Docket Nos.: 52-025
52-026

ND-18-1037
10 CFR 50.90
10 CFR 52.63

Southern Nuclear Operating Company
Vogtle Electric Generating Plant Units 3 and 4
Request for License Amendment and Exemption:
Power Operated Relief Valve (PORV) Noise Mitigation (LAR-18-021)

Figure 2.2.4-1 (Sheet 1 of 3)
Steam Generator System

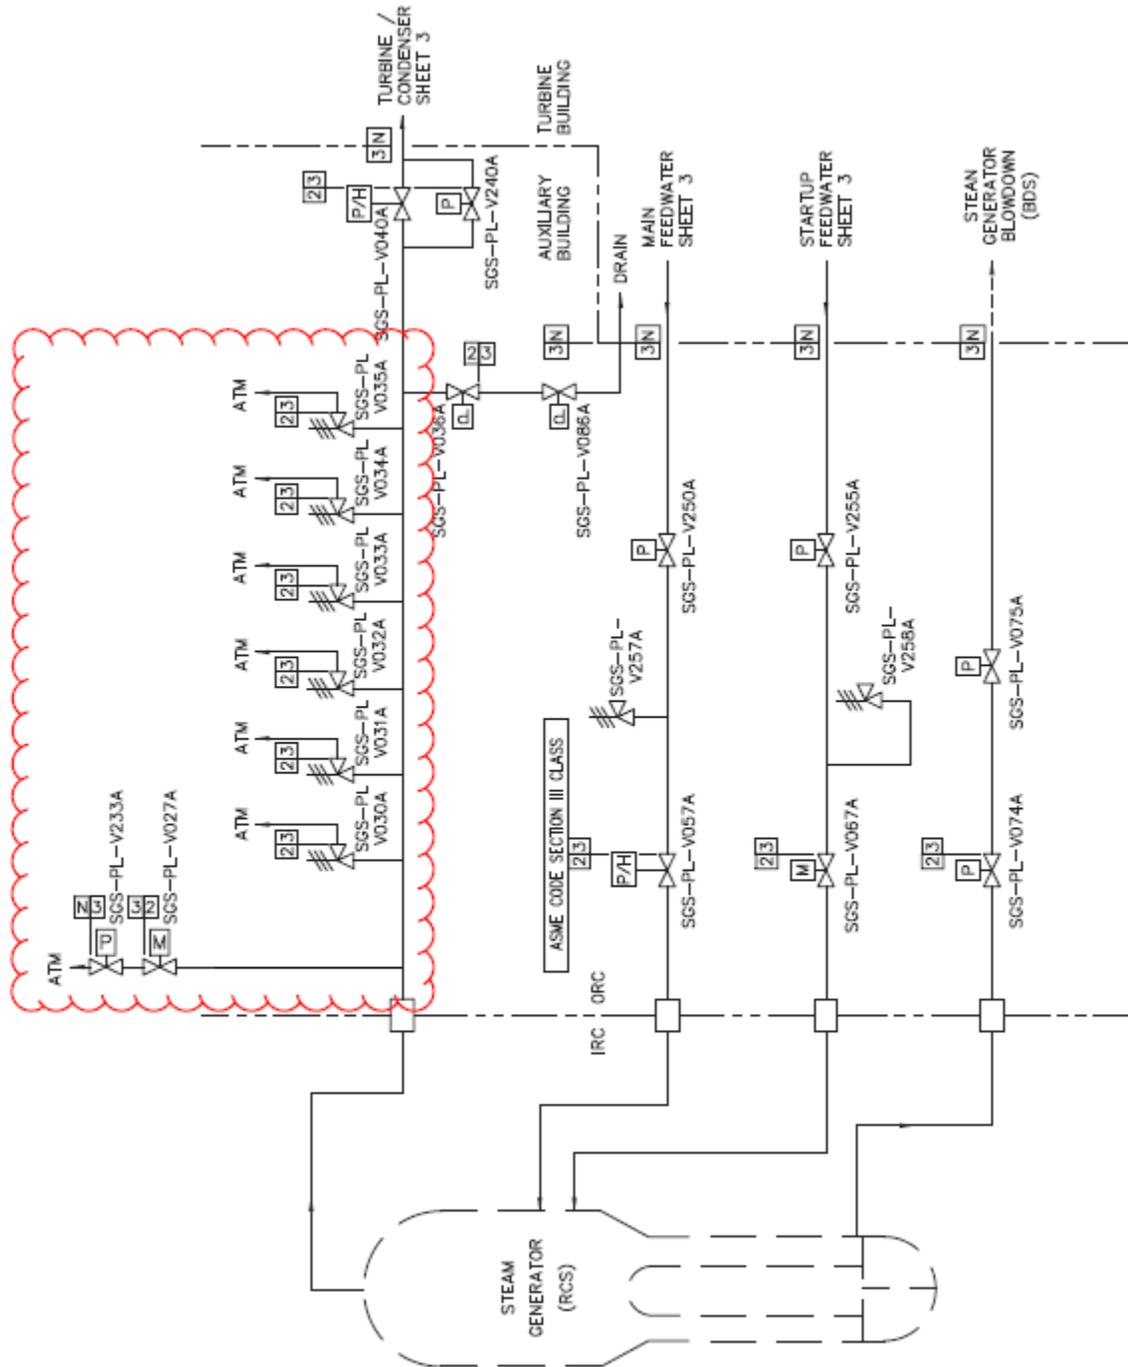
Revise COL Appendix C (and corresponding plant-specific Tier 1) Figure 2.2.4-1, sheet 1 to relocate the branch line to the PORV as shown below:

Figure 2.2.4-1 (Sheet 2 of 3)
Steam Generator System

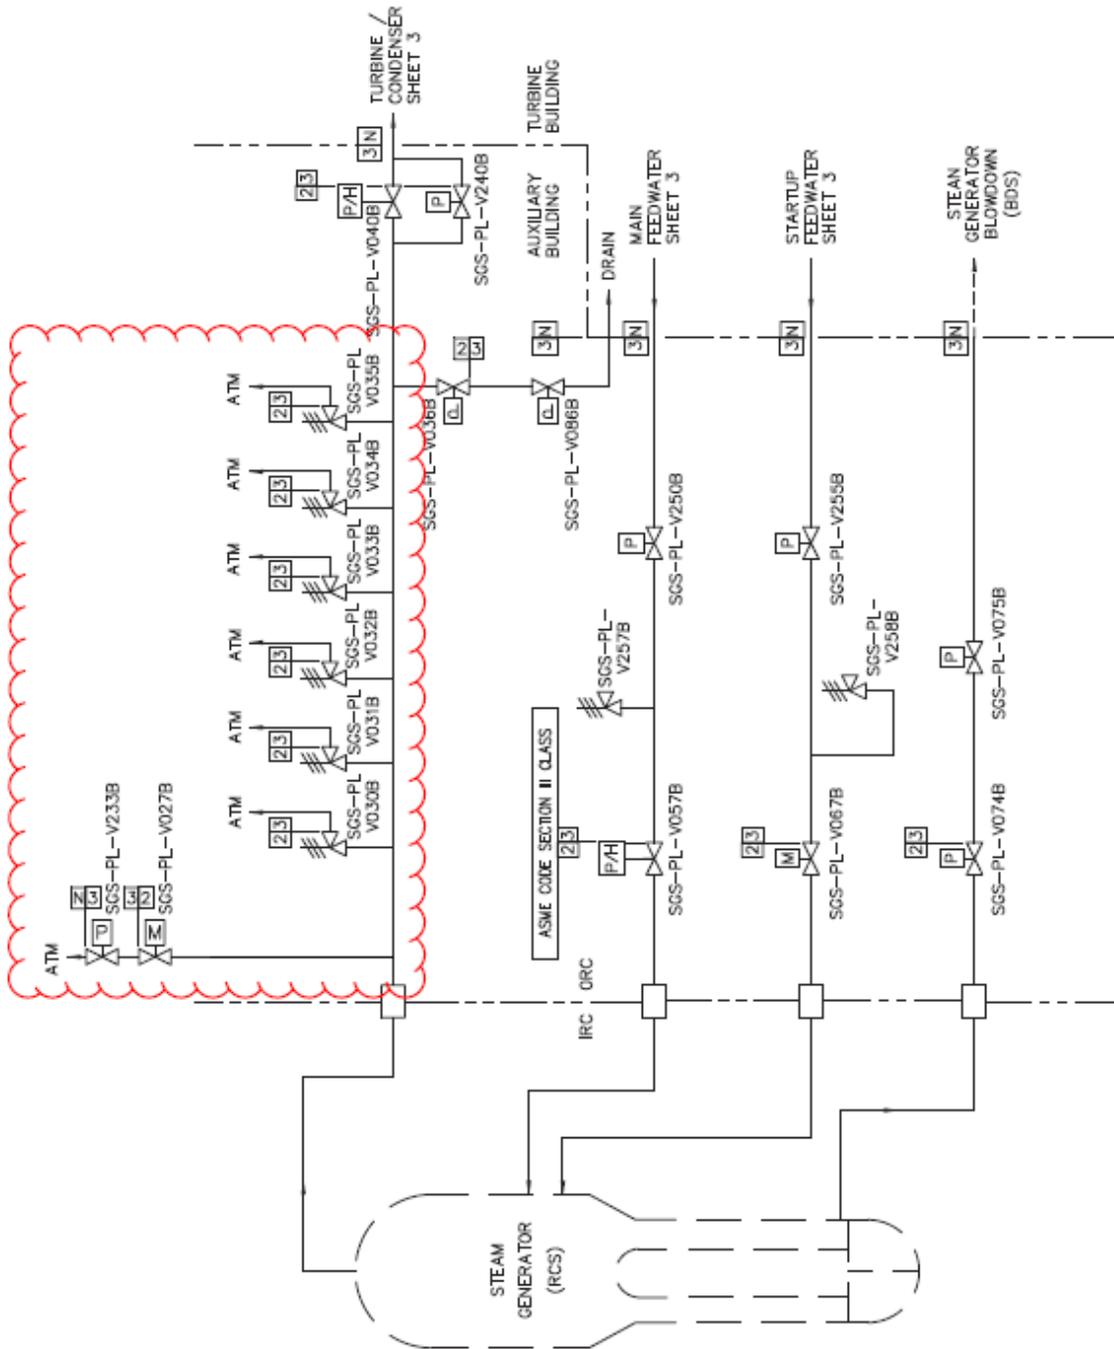
Revise COL Appendix C (and corresponding plant-specific Tier 1) Figure 2.2.4-1, sheet 2 to relocate the branch line to the PORV as shown below:

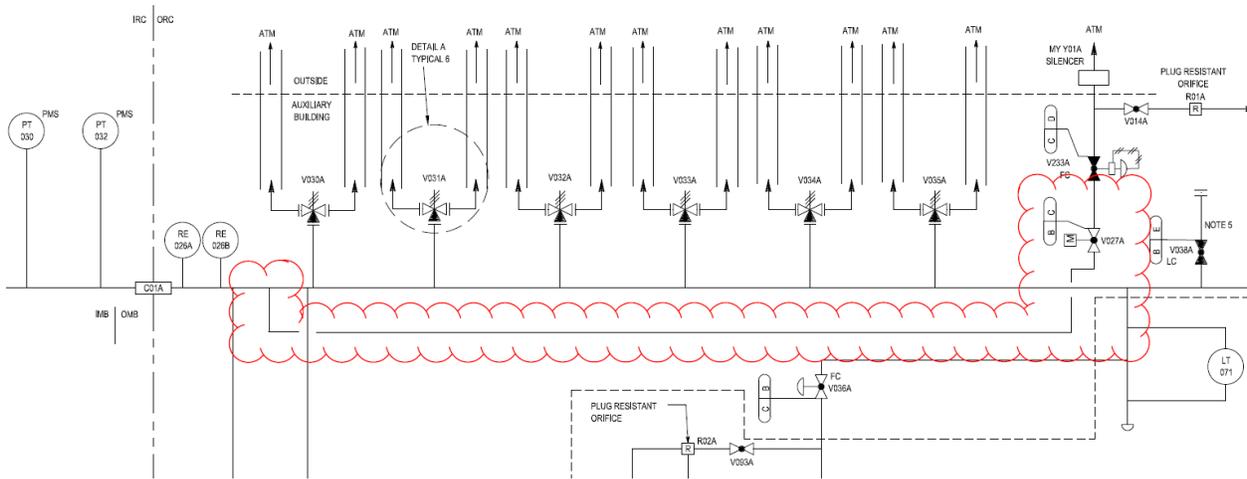
Revise UFSAR Figure 10.3.2-1 (Sheet 1), to change relocate the branch line to the PORV and PORV block valve and to change the PORV block valve from a gate valve to globe valve, as shown below:

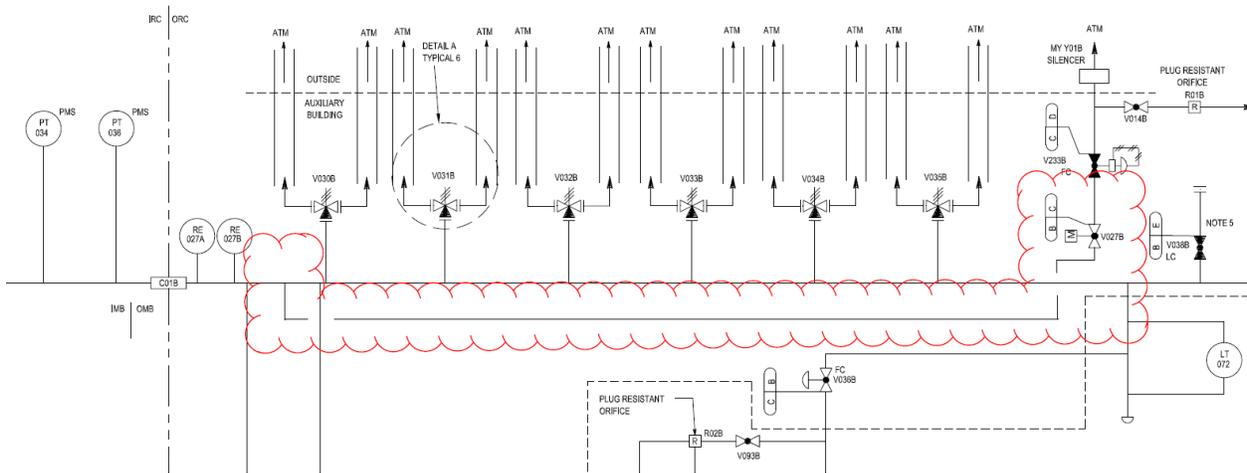
Revise UFSAR Figure 10.3.2-1 (Sheet 2), to change relocate the branch line to the PORV and PORV block valve and to change the PORV block valve from a gate valve to globe valve, as shown below:
